CLIVE PLANNING & ZONING COMMISSION

RE: Site Plan - Linnan Park - 8500 Alice Ave

Re: 8500 ALICE AVE - Linnan Park - Site Plan

90% Revised Set

CV100

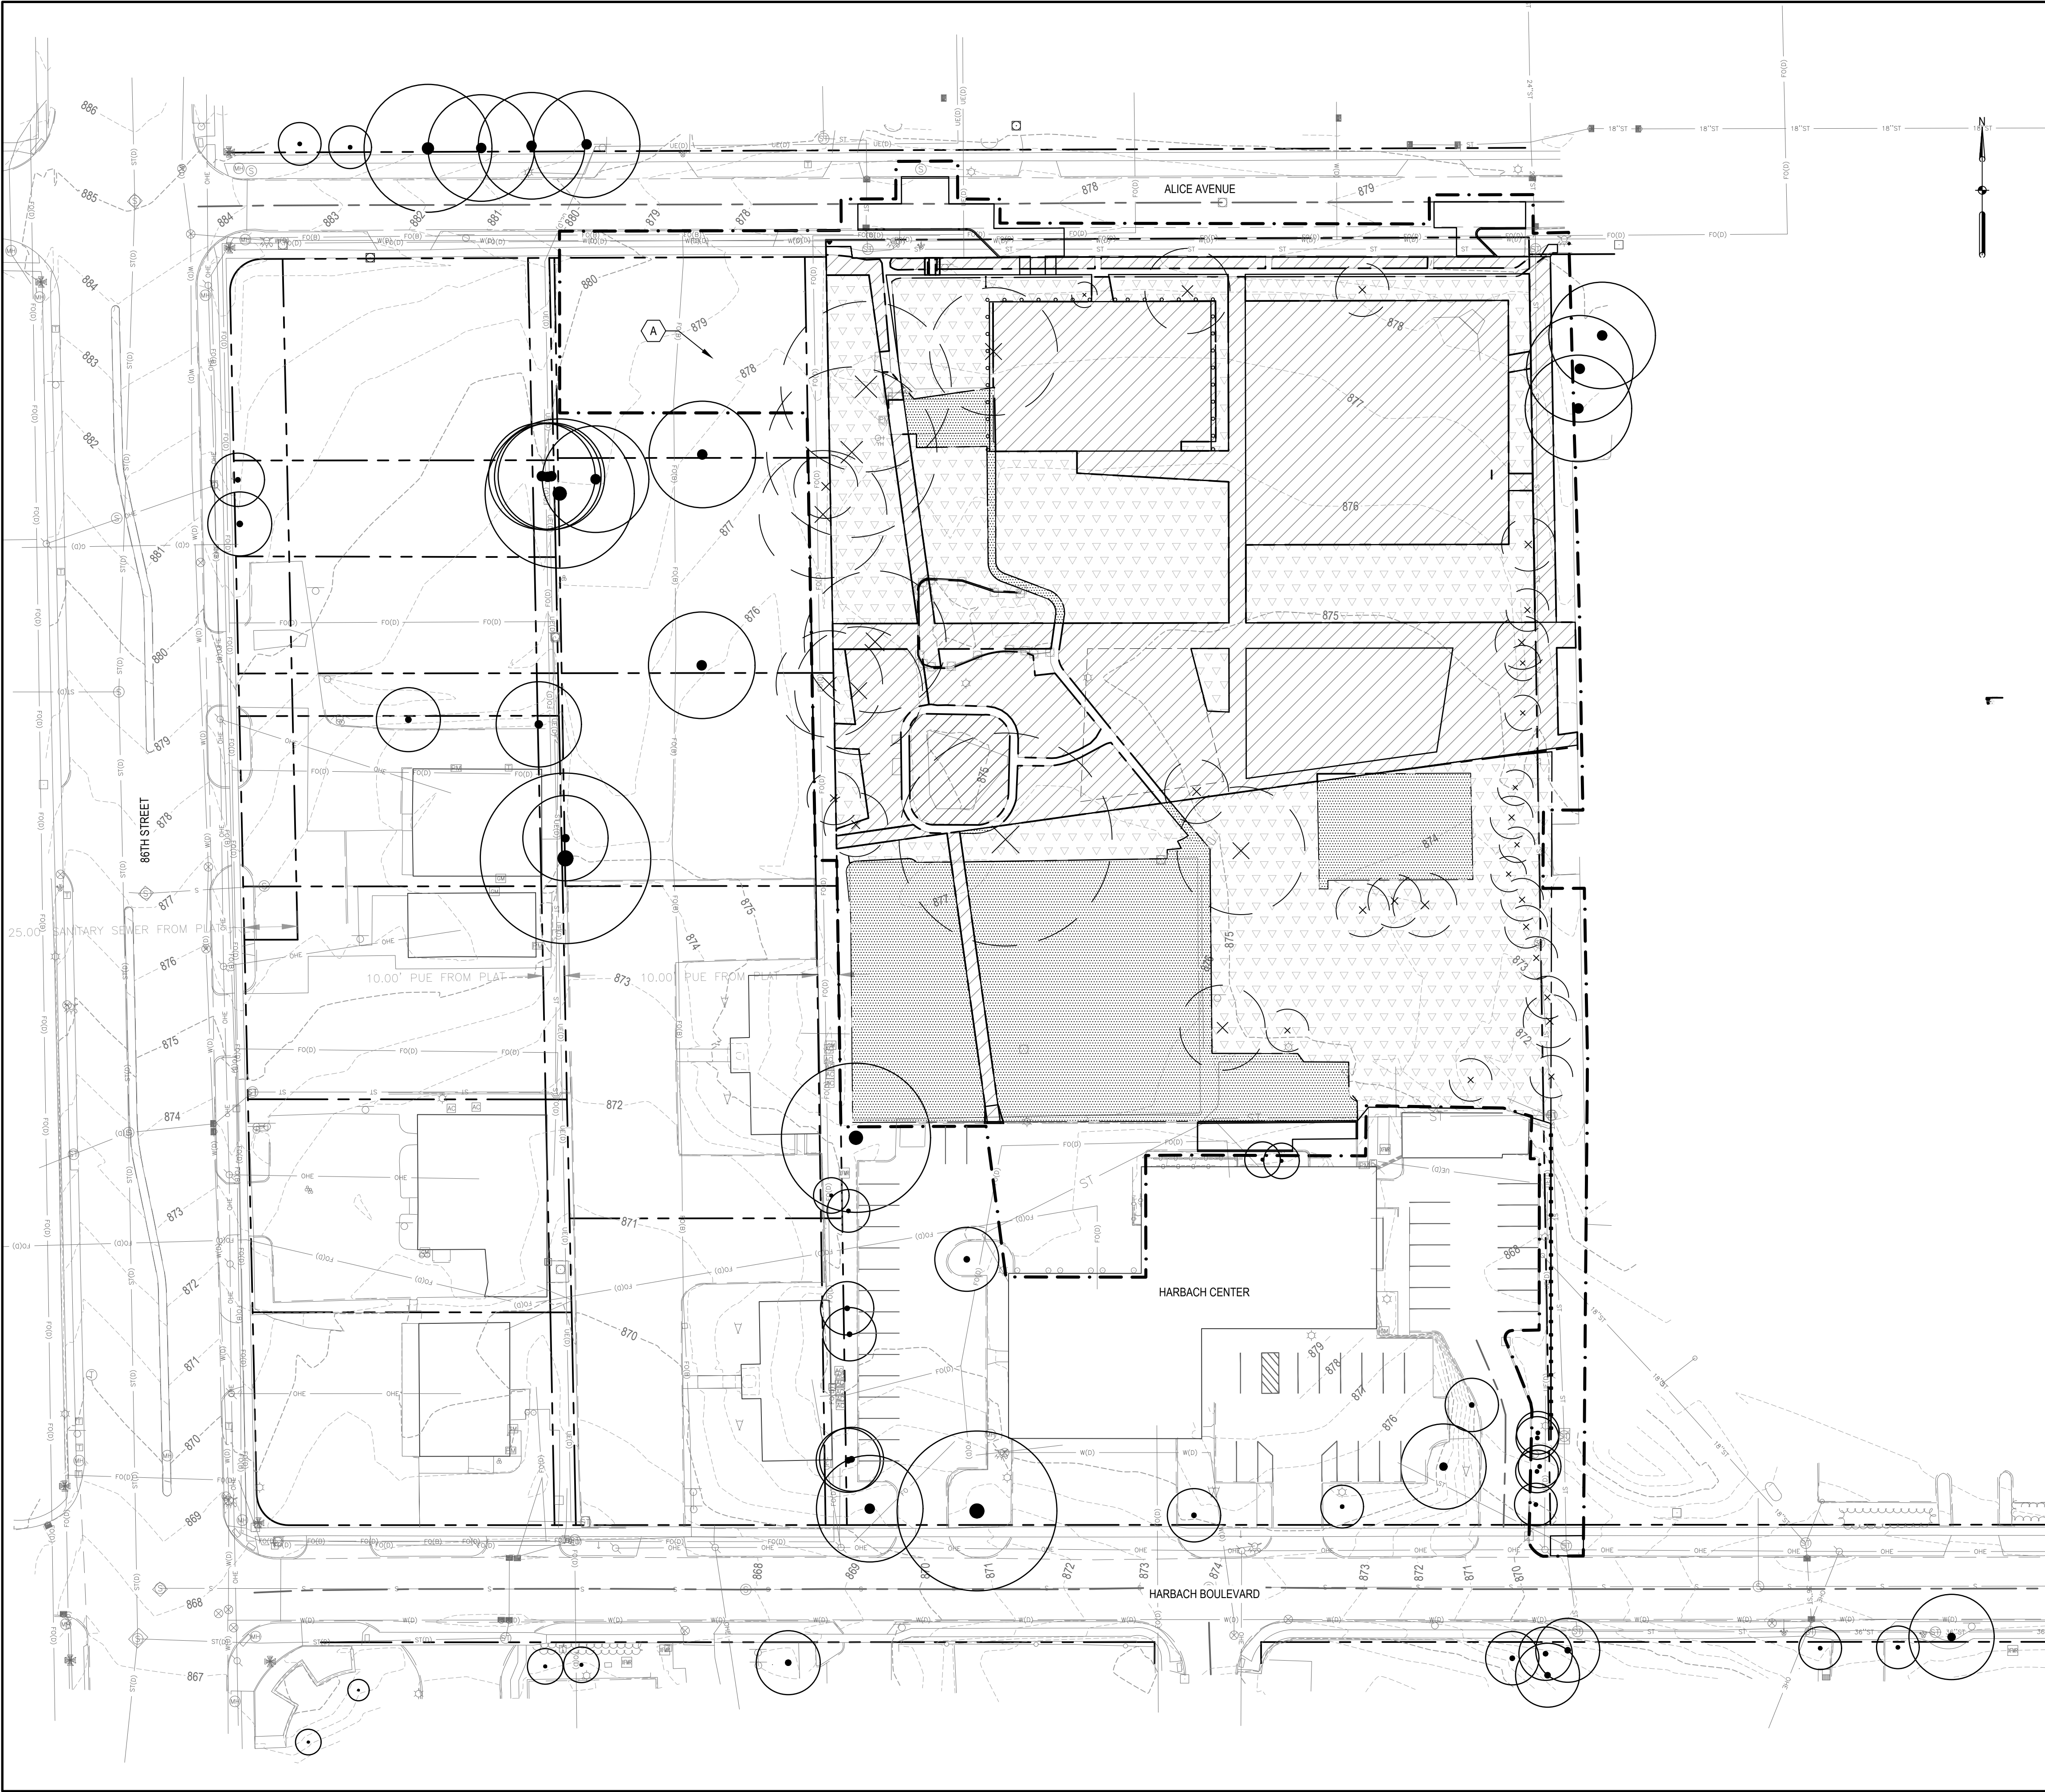
1. Identify the City of Clive Benchmark used. Please include this information on the cover sheet.
2. CV100 : Provide additional information on existing storm sewer. The invert is not determined for structure DIP04023 connecting to ST-15 (shown on Sheet CU101).

C-002

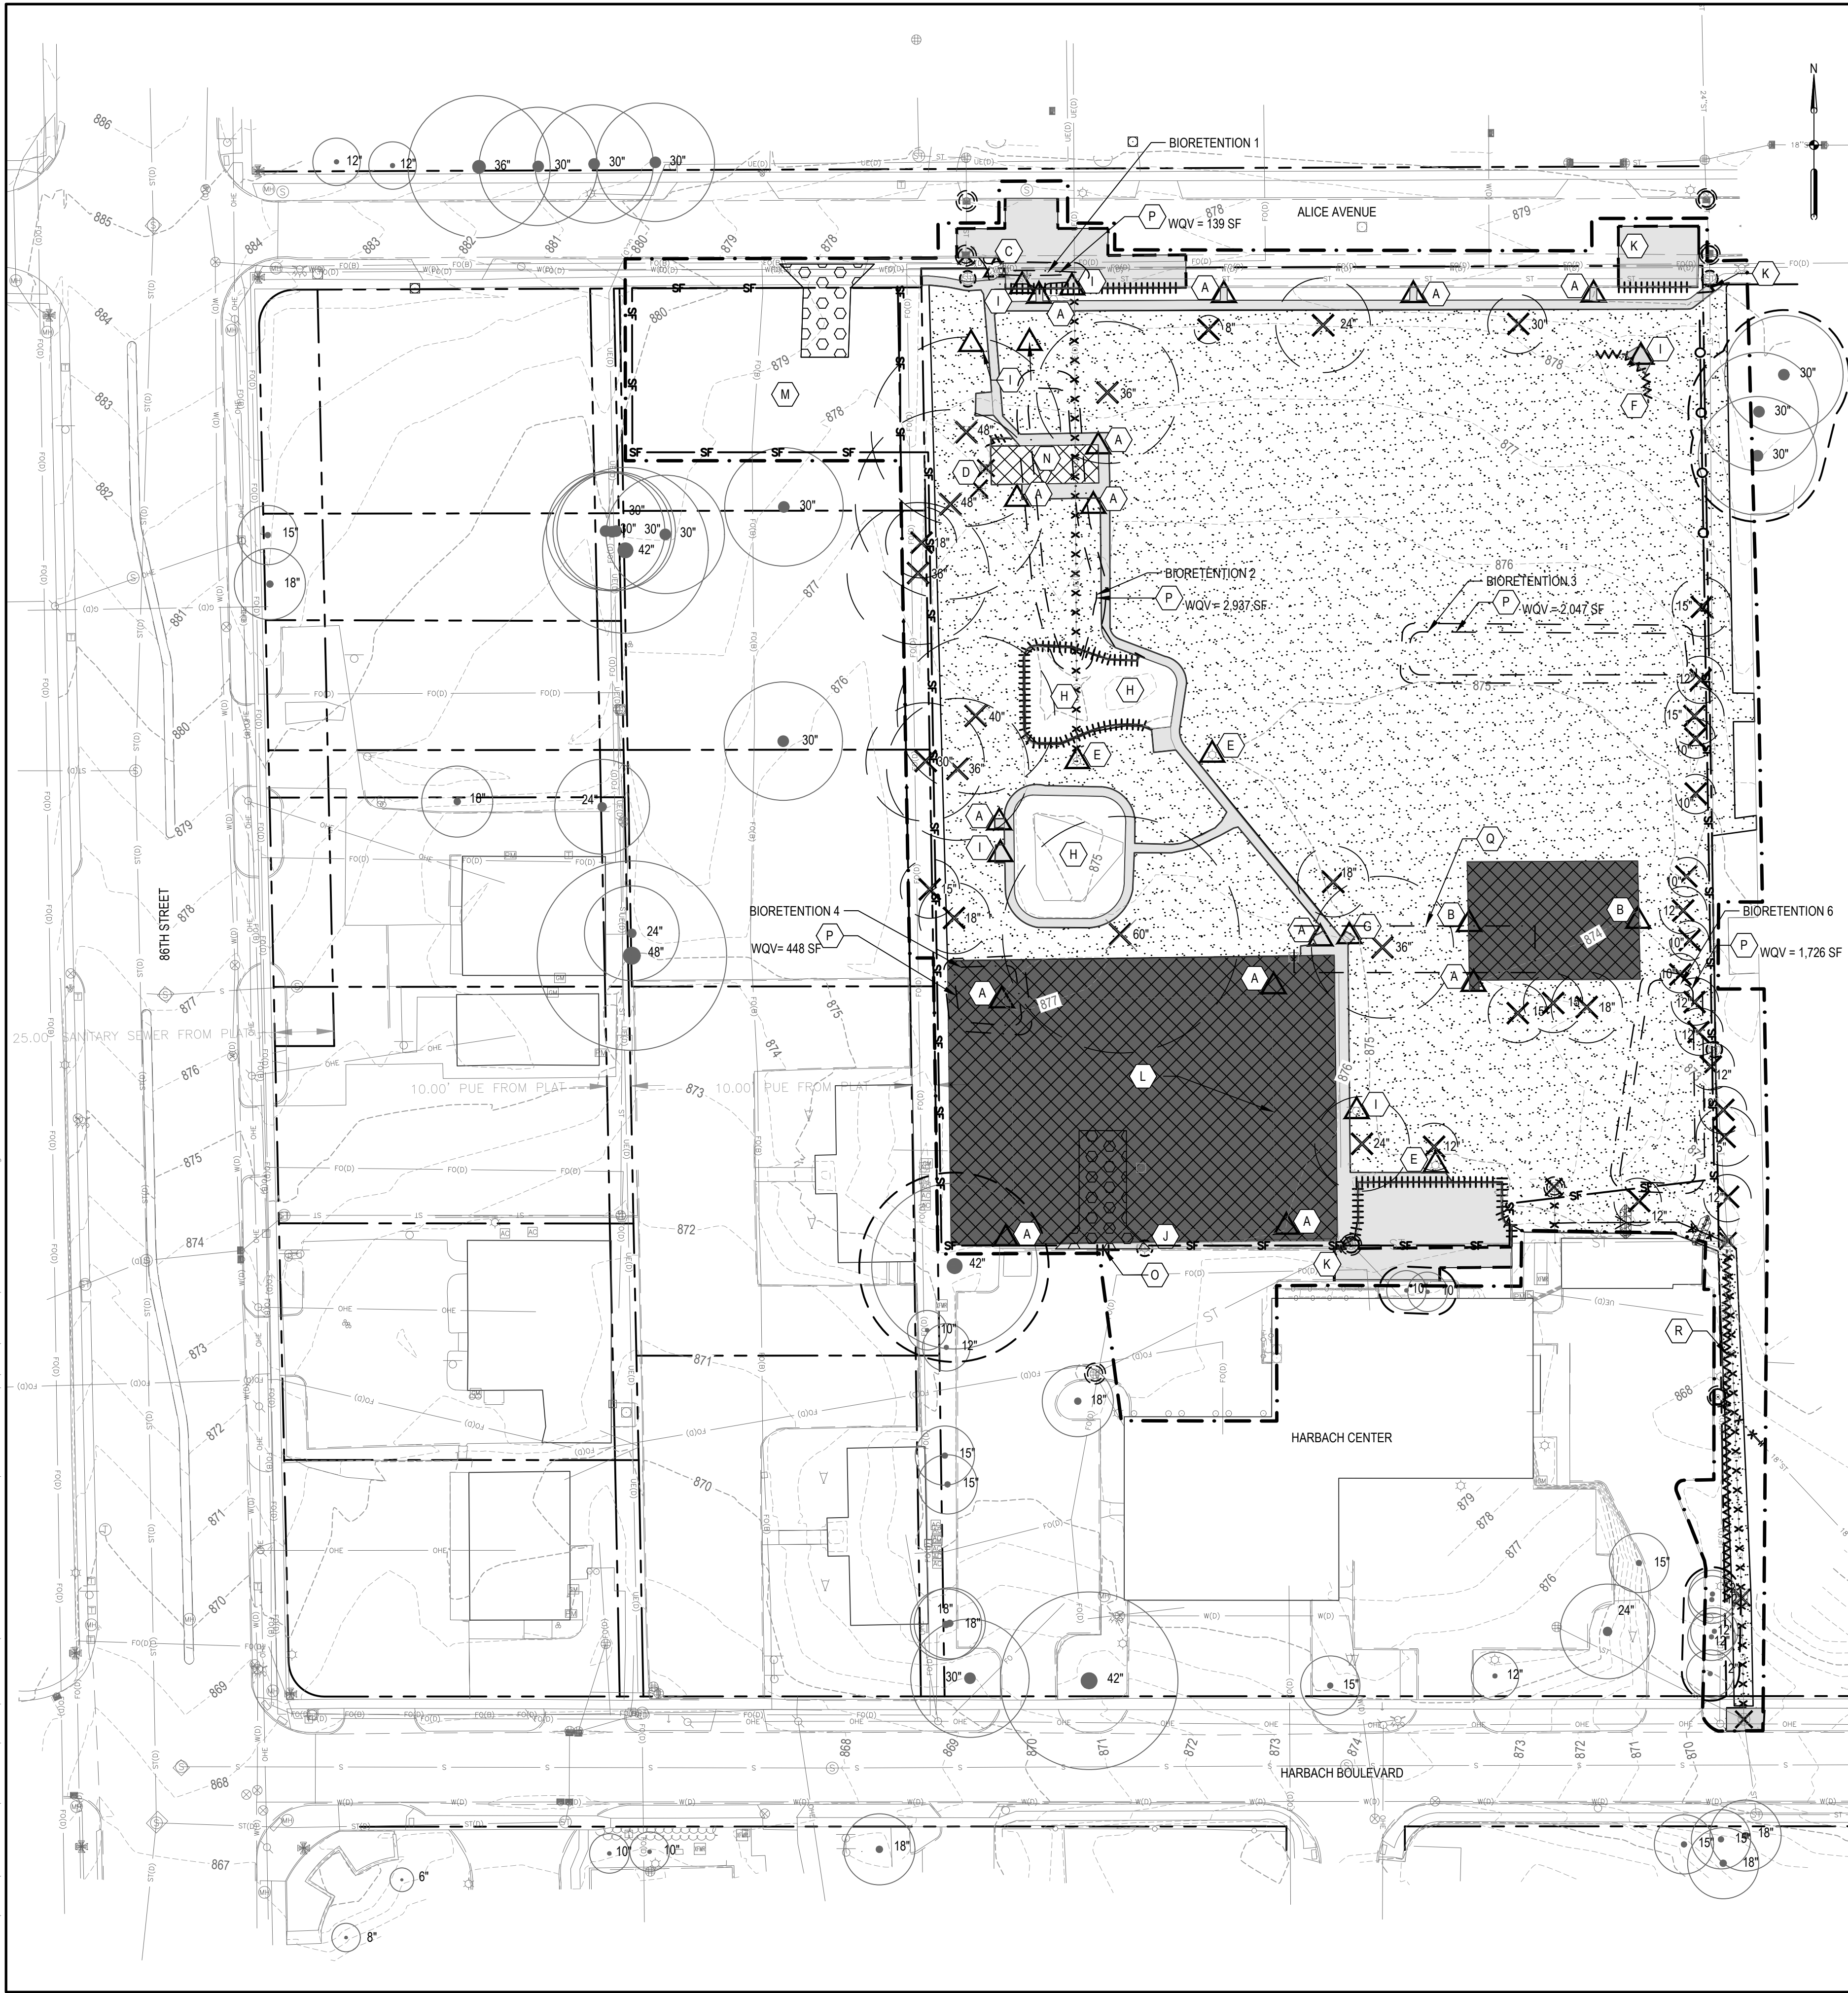
1. C002 -- add note that final condition of stockpile location to match topsoil spec. For example, ""After use, provide soil restoration at stockpile location consistent with the decompaction and soil quality of rest of the site."
2. CG101 -- Carry flume inverts from CU100 bioretention cell 1 (Alice Ave).

CU100

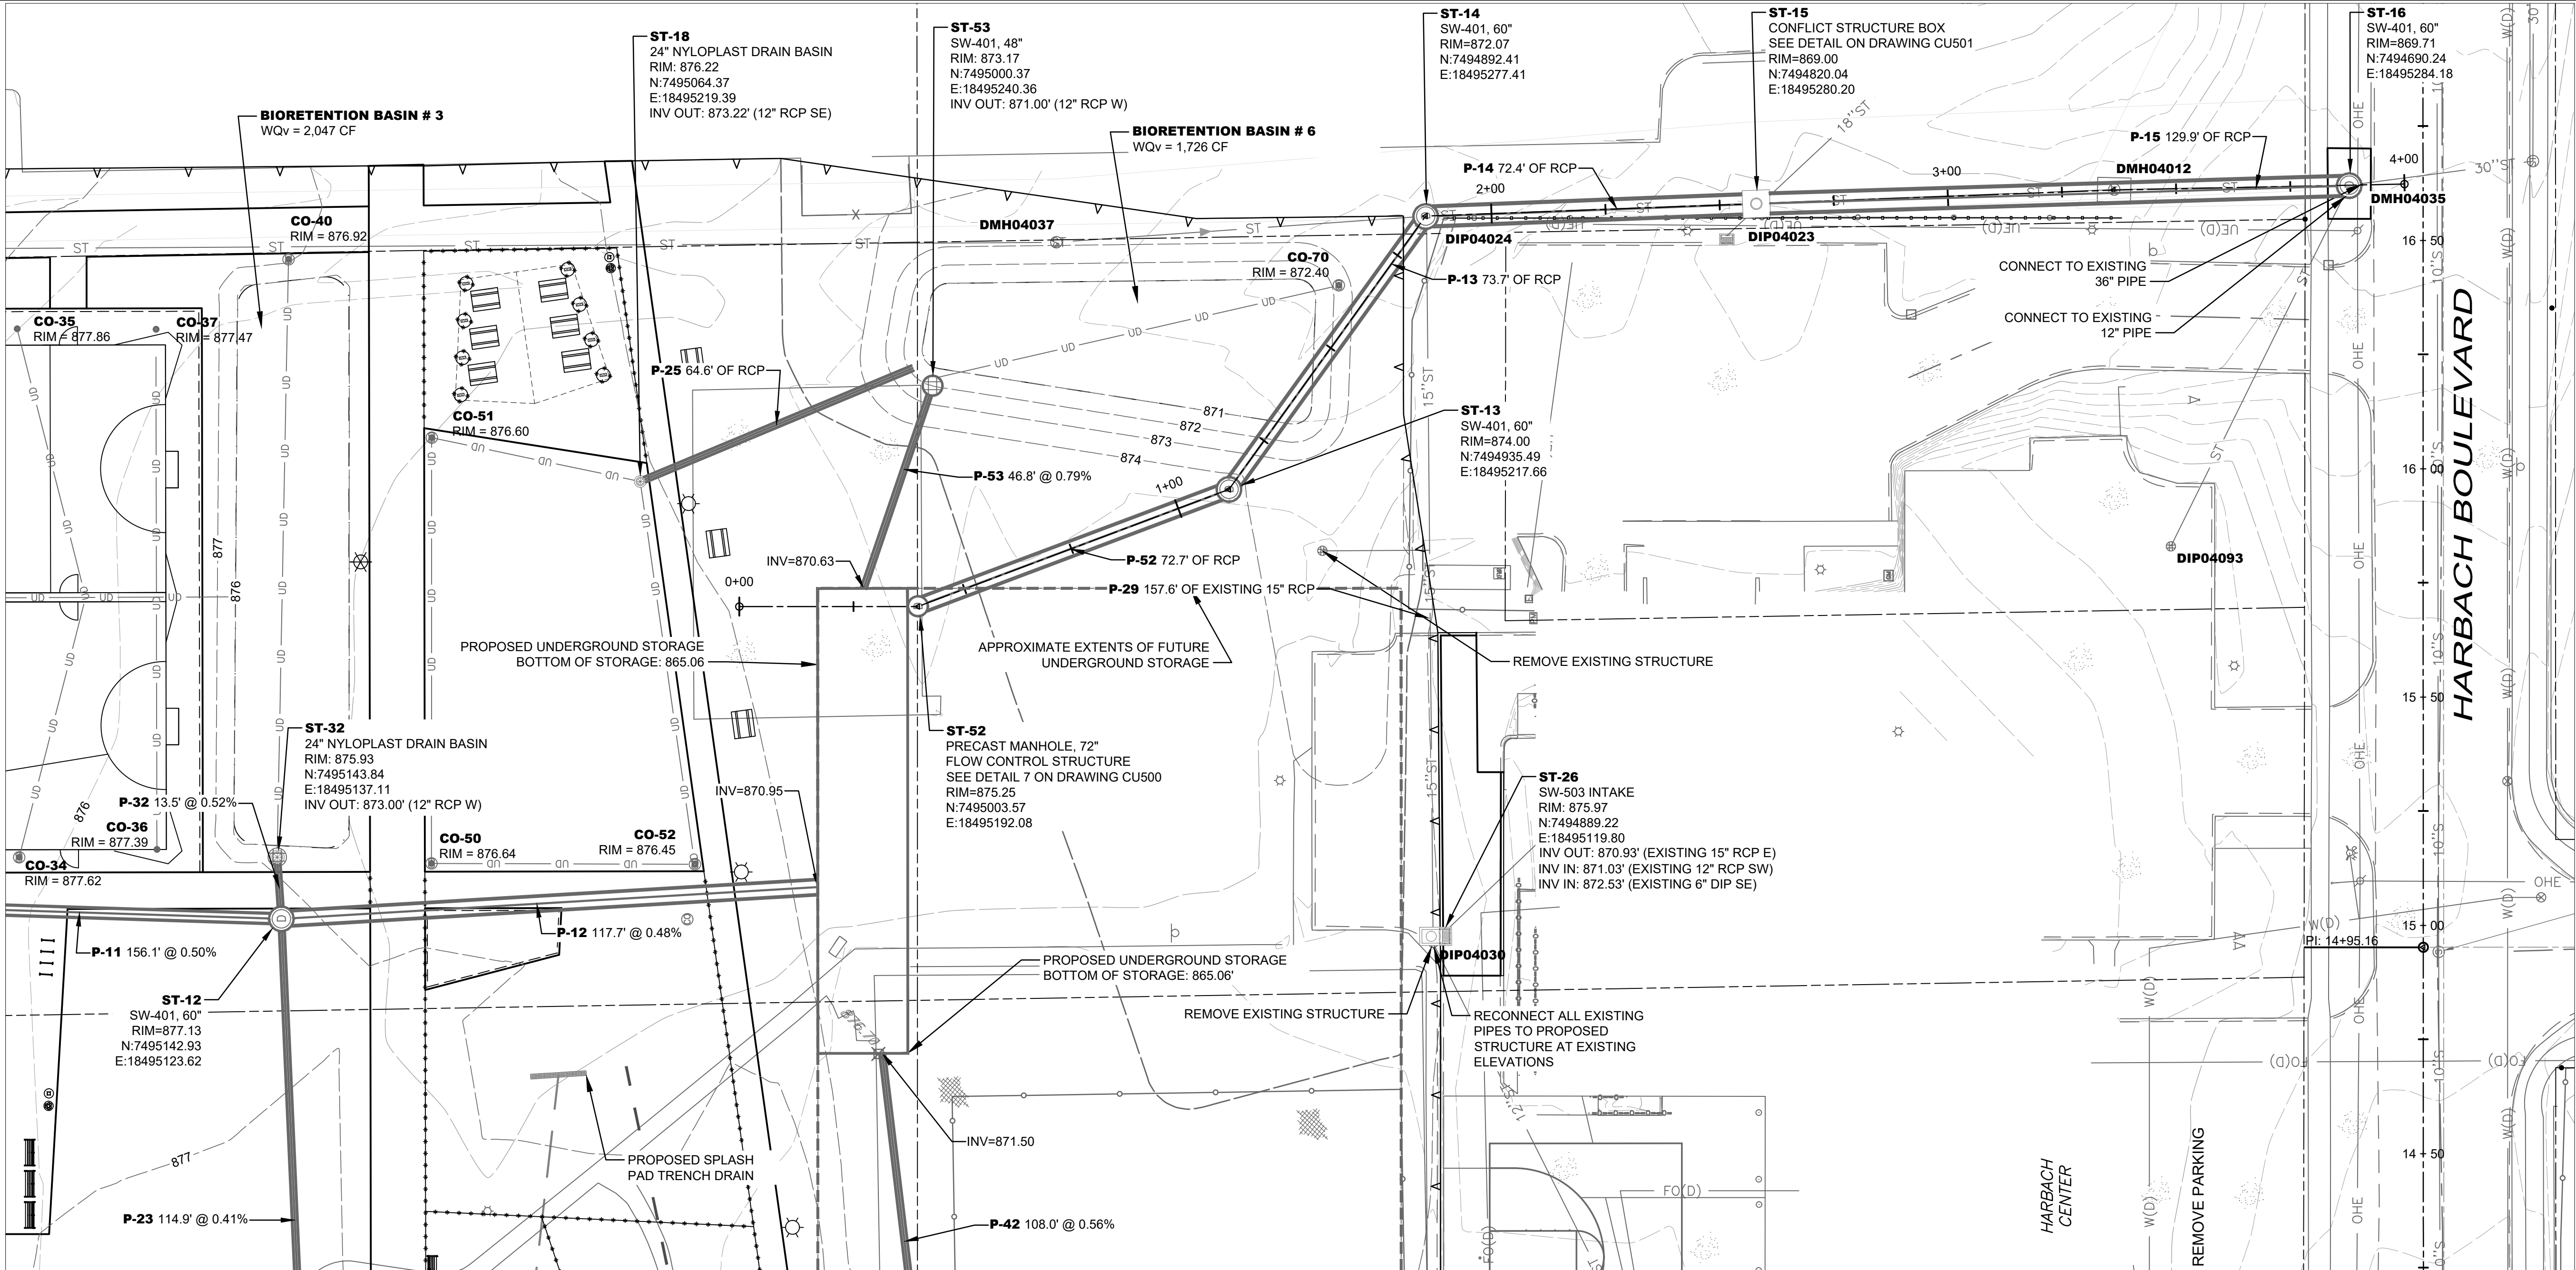
7. CU100, CU102 - 877 contour near sidewalk flume does not match CG101
8. CU101-- Bioretention cell 3 rim does not appear to match plan set; Cross reference SWMP.

9. CU101-- Bioretention cell 4 rim does not appear to match plan set; Cross reference SWMP.
10. CU100 - Bioretention cell 4 missing cleanout information.
